2. TUSCAN VILLAGE MASTER PLAN UPDATE 3.0

PLANNING BOARD AGENDA FOR SEPTEMBER 22, 2026 - 7:00 PM

1. **Tuscan Village Master Development Site Plan** – Conceptual Discussion on revised master plan for Tuscan Village to include 120-key hotel, 392 apartments, 72 workforce housing units, medical office, general office, bank, and restaurant uses at 14-24 Tuscan Blvd, Map 107, Lot 12605. Continued from 7/28/2026.

TUSCAN VILLAGE MASTER PLAN UPDATE

OVERLOOK PARK CONCEPTUAL PLAN

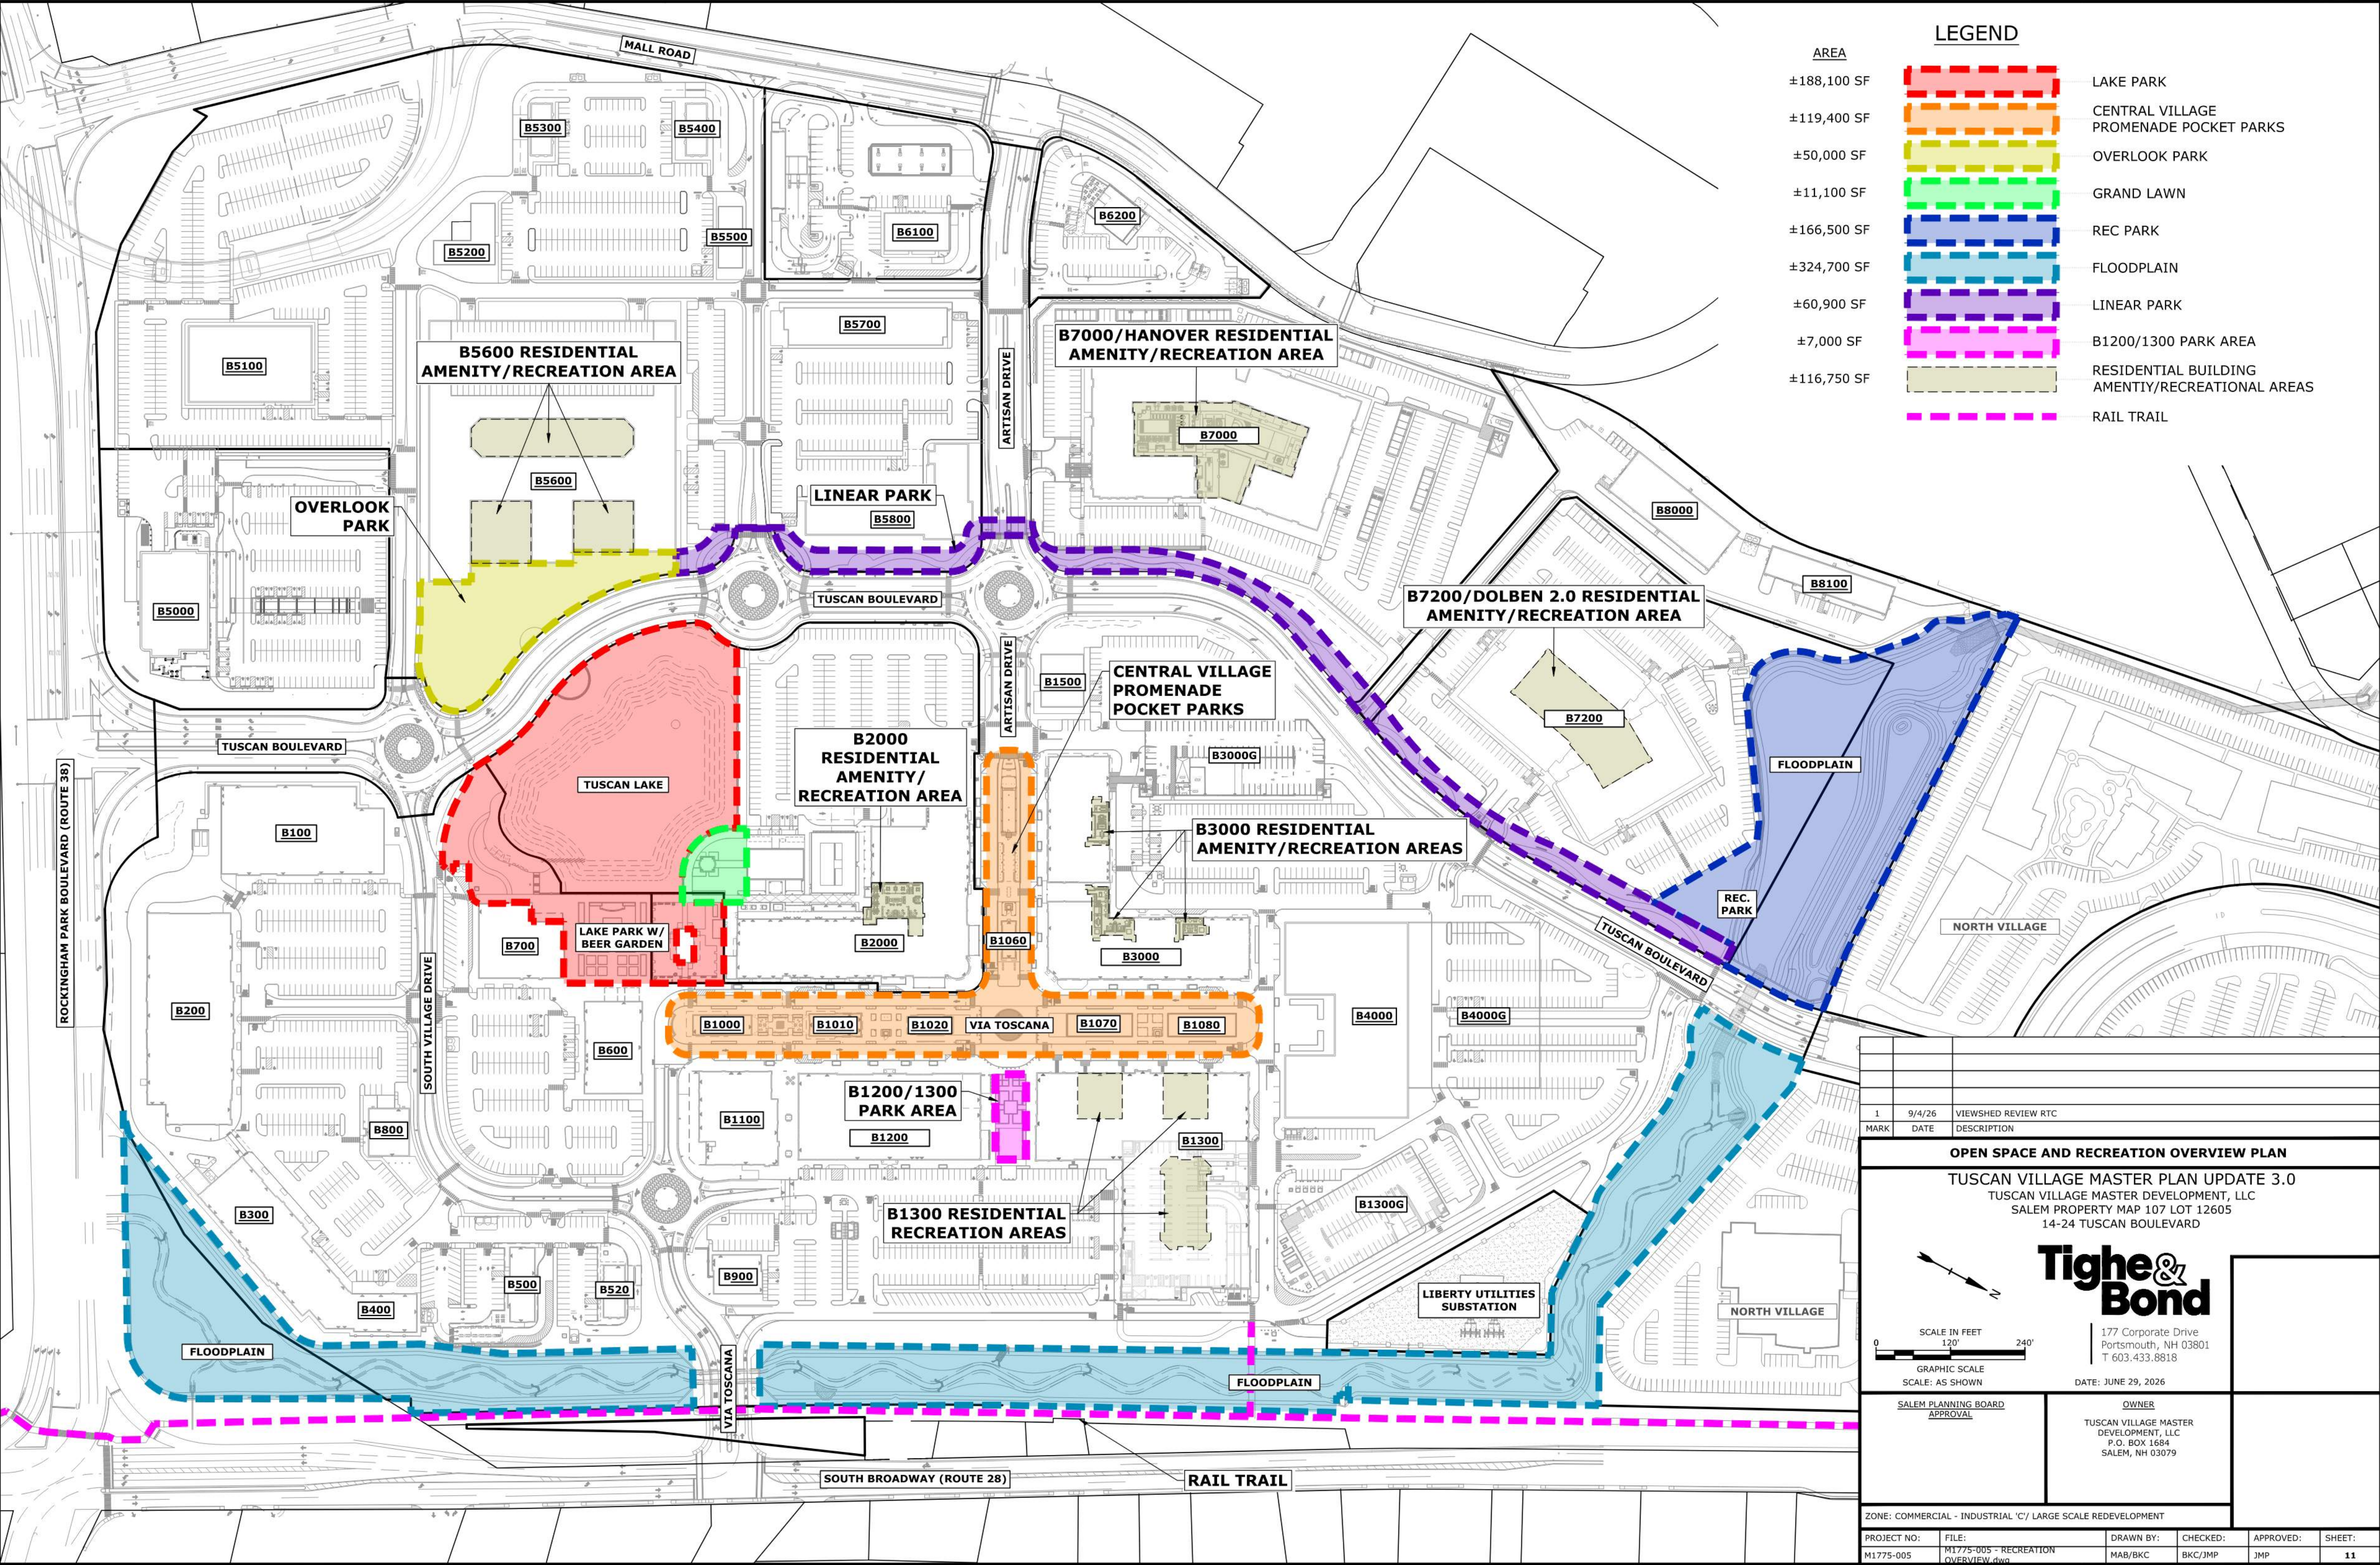
Comment 39: *Overlook Park and Linear Park adjacent to Building 5600. The proposed public open space, Overlook Park, is shown on the renderings as a large open lawn ringed by an oval paved walkway, with an open paved area to the north serving as an overlook near Tuscan Boulevard. A semi-circular paved area connects the paved oval to the sidewalk along Tuscan Boulevard (also termed the Linear Park). The sketch on Sheet 13 shows an alternate layout for the park that is not reflected in any of the other drawings in the submission. That sketch and Sheet 12 have not been updated to reflect the projecting wing of the apartment building that reduces the park space and will impact the park design significantly. On Sheets 19 and 21, there are clear views of how the new projecting wing of the apartment building is directly connected to Overlook Park's paved oval. The physical connection of the private building to the public space is visually confusing, and makes the space appear as if it is for the use and enjoyment of the building's residents rather than for the public. The sketches on Sheets 12 and 13 indicate some private spaces adjacent to the public areas of Overlook Park, but the sketches have not been updated to match the new plans, so the current extent of the private space is unclear. The Applicant should provide updated drawings that clearly delineate public vs. private space and update the Open Space calculations on Sheet 11 accordingly.*

Response to Comment: In response to Viewshed's comments, as well as Planning Board and Town Staff feedback, the Applicant has presented an updated concept plan for Overlook Park that enhances the public's enjoyment of this open space, and has committed to at an Overlook Park that is at least the area shown in the 2025 submission. Sheet 11 has been updated accordingly.

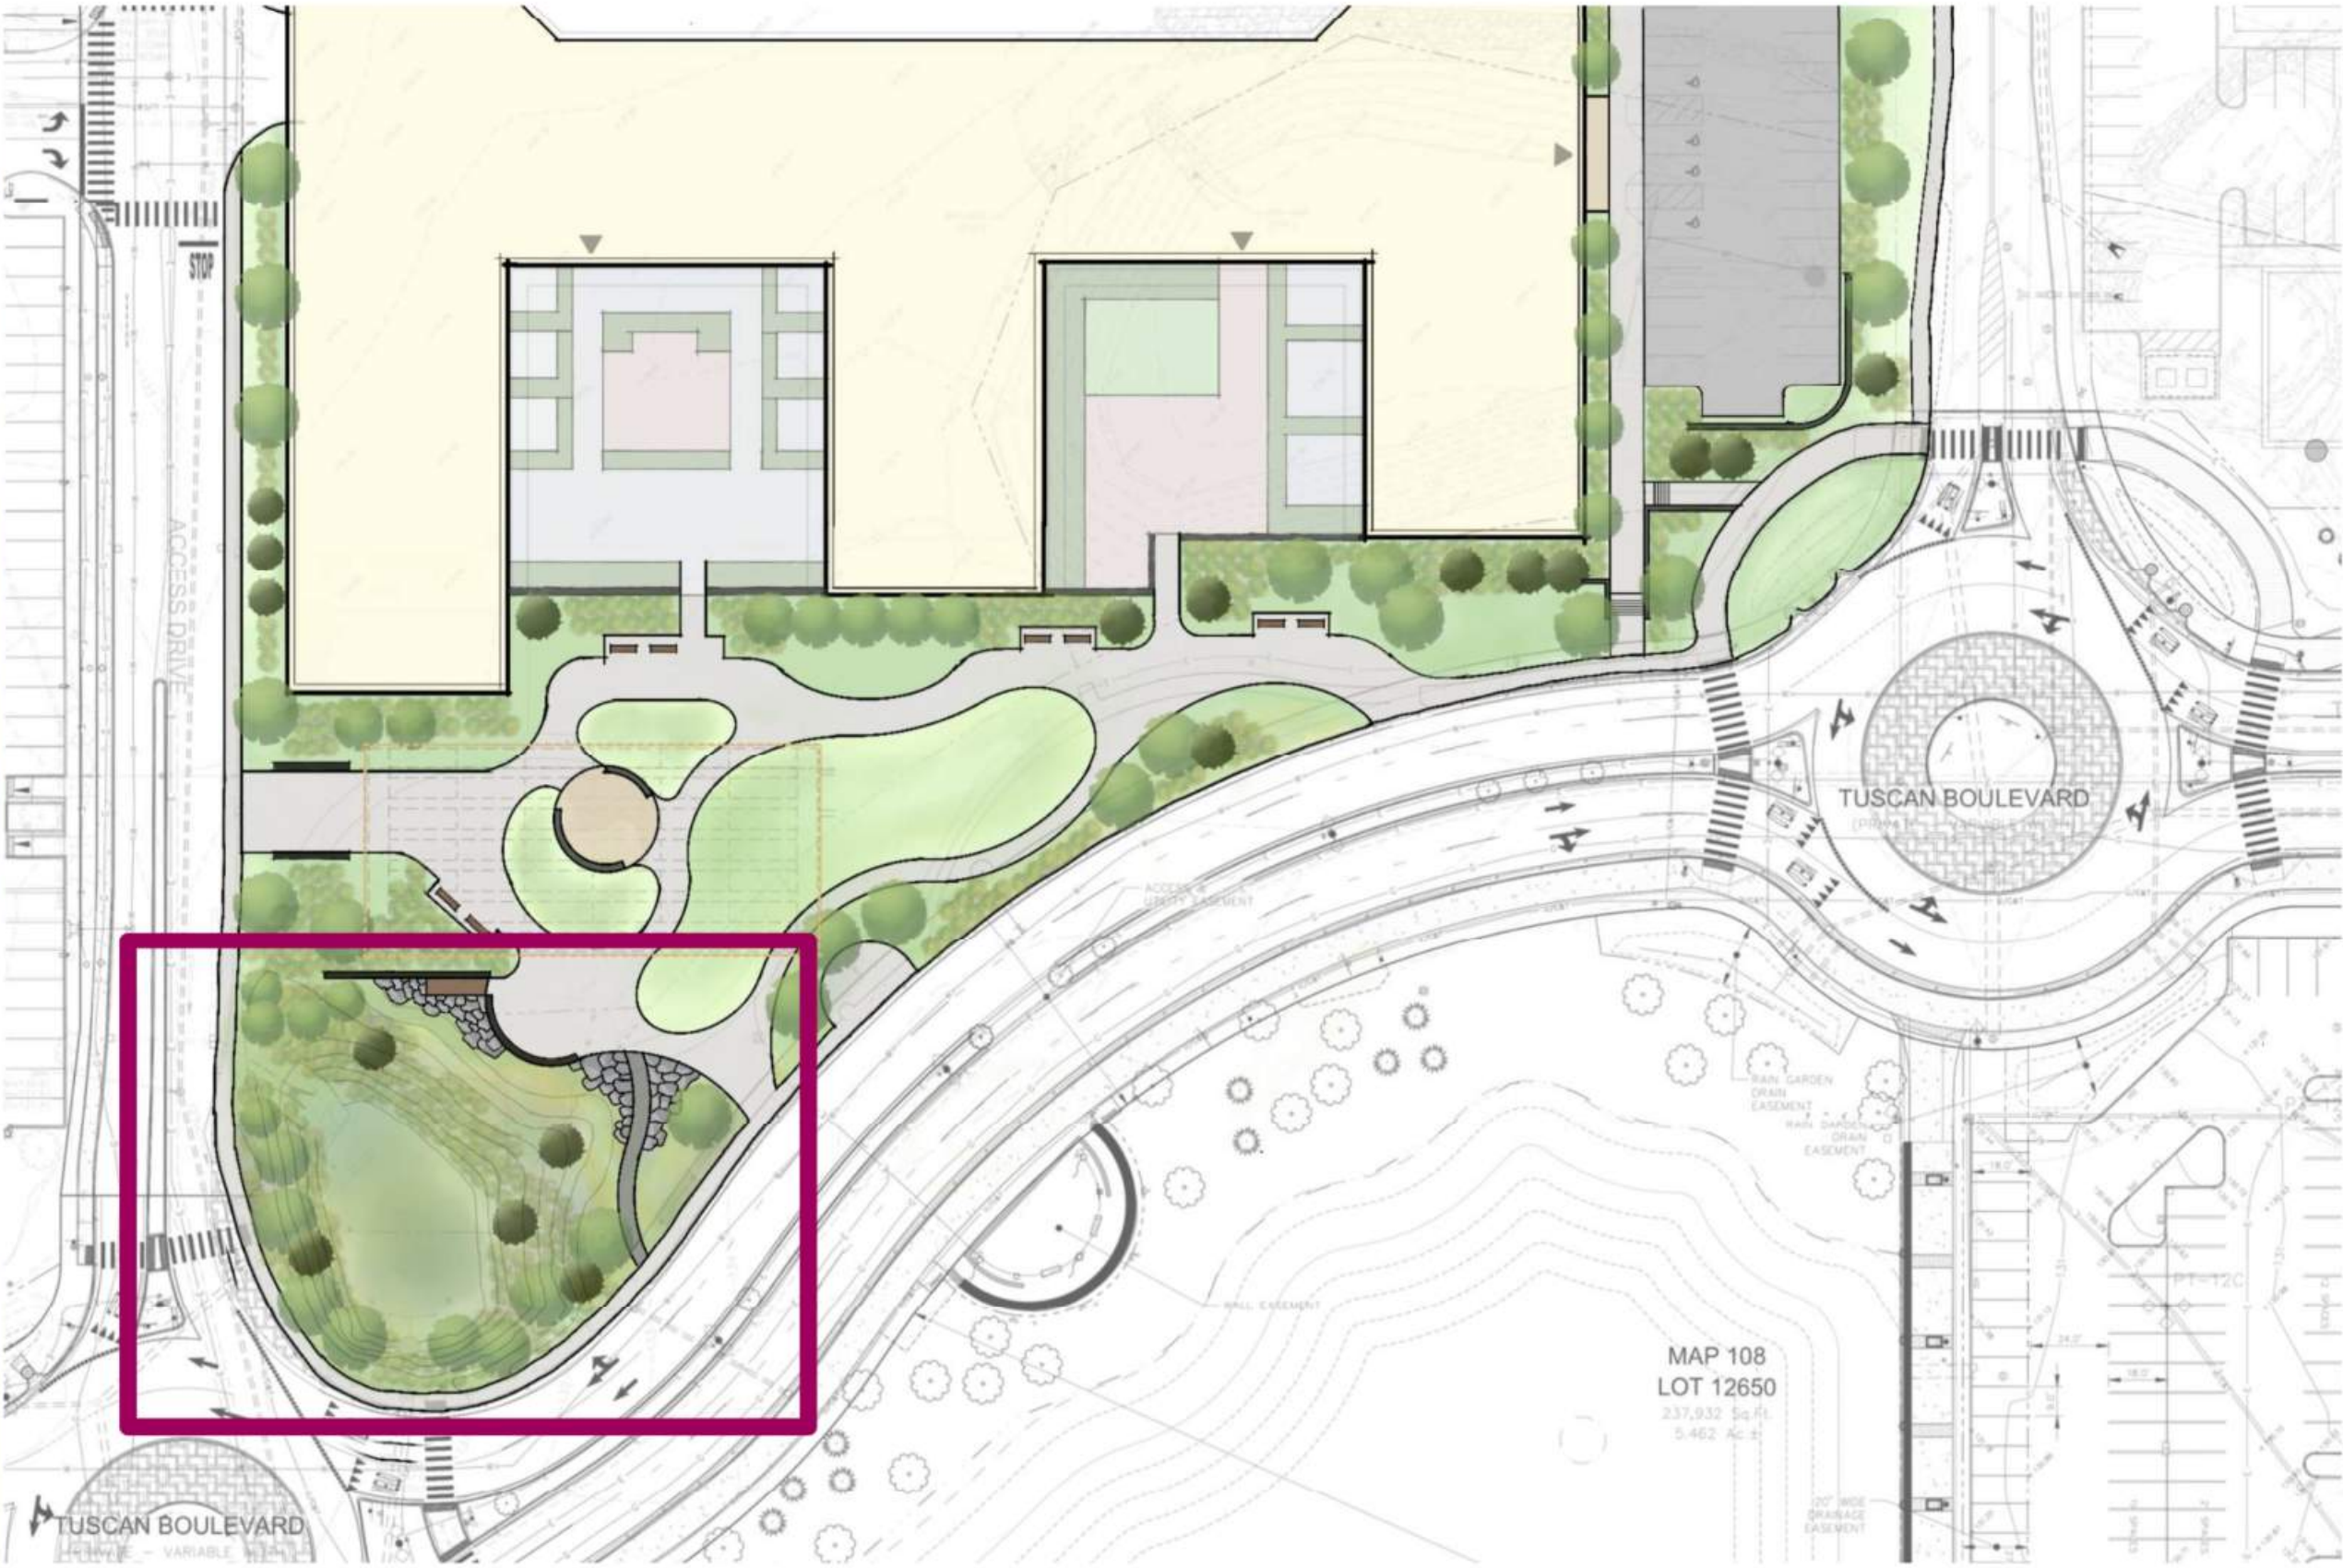
Comment 42: *Since no grading information was provided, the only information for this area is the rough sketch provided in Sheet 12, Overlook Park Concept 1.3. However this sketch has not been updated during the last year and does not reflect the impact of the expanded building footprint. It is unclear whether the park will actually overlook or have any visual connection to Tuscan Lake (which would be ideal).*
